September 15, 2015

Subject: SANITARY SURVEY OF KINGSBURY GID (NV0000004); DOUGLAS COUNTY

Attachment #1

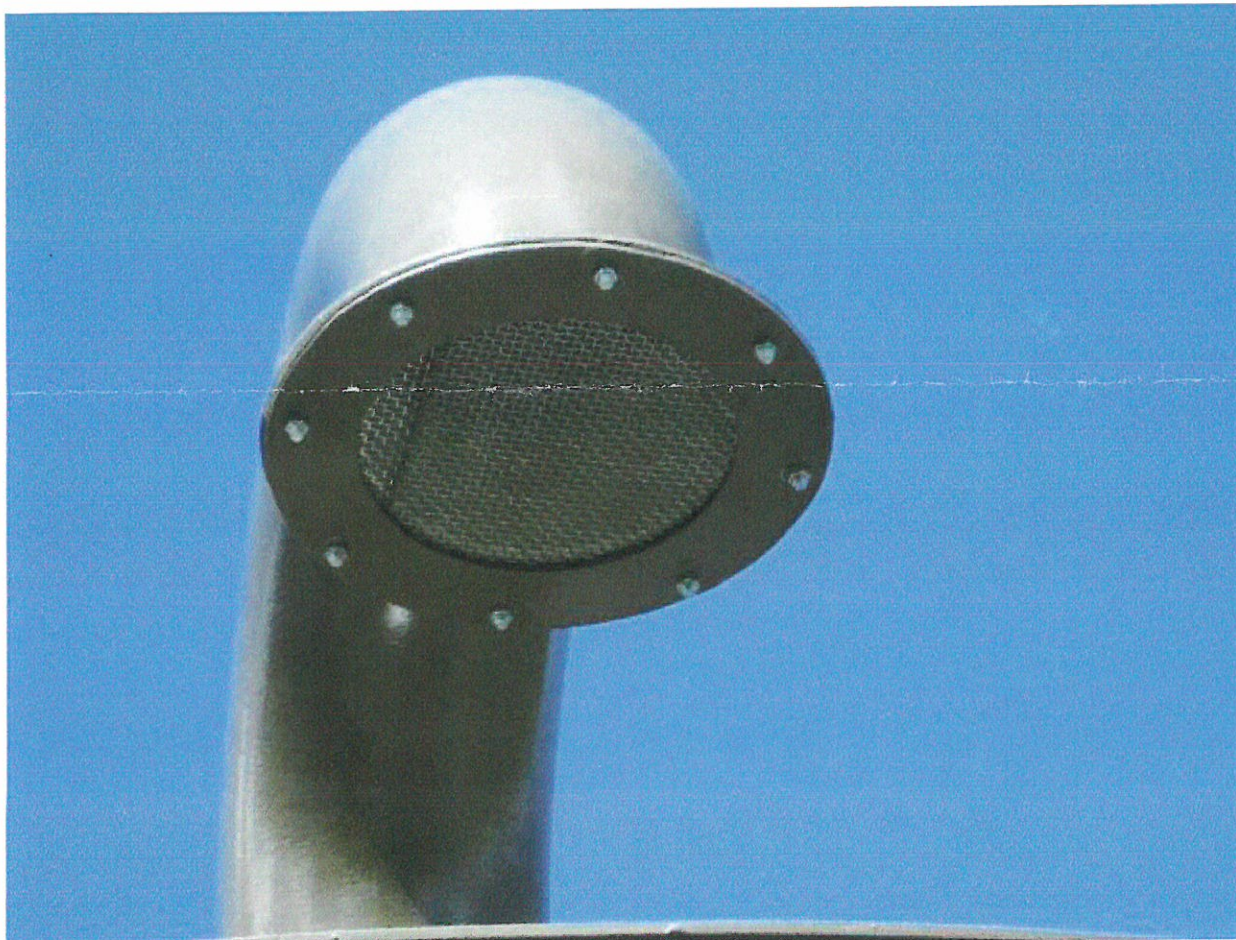
SURFACE WATER PLANT STN 1 FIN		
Comments: Vent screens for new finished water tank at new treatment plant appear to be too coarse. See Attachment #1

Attachment Comments: Vent screen
